Manual addendum for: PL-REM

Change Relay A/B mode

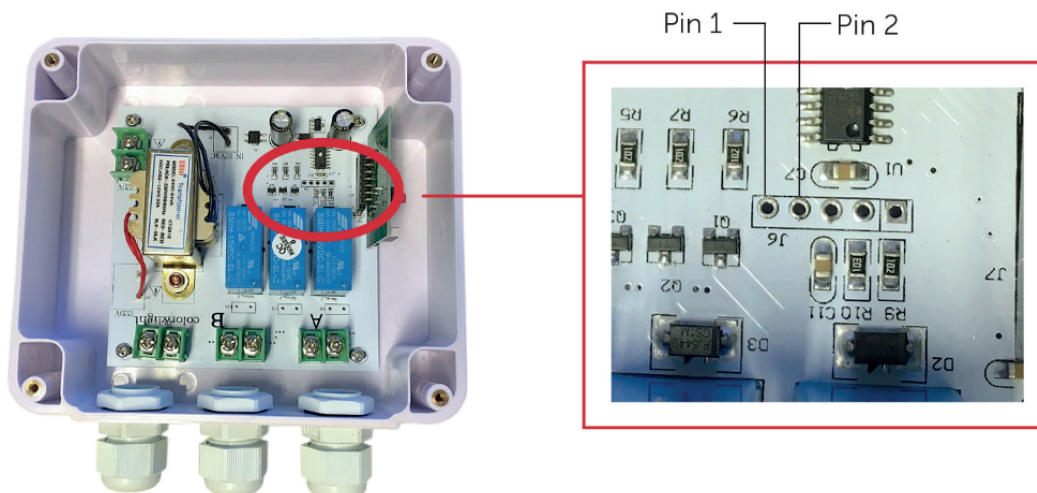
1. Locate the 5 pinholes on the circuit board.
2. Make a connection between pin 1 and 2.
(use a piece of wire, or a paperclip)
3. Power ON the device by connecting a 230VAC power source to the 220-240VAC INPUT terminal.
4. Power OFF the device.
5. Remove the connection between pin 1 and 2.

Every time the above process is repeated, the A & B relays switch between Normal open/closed mode and Pulsed operation mode.
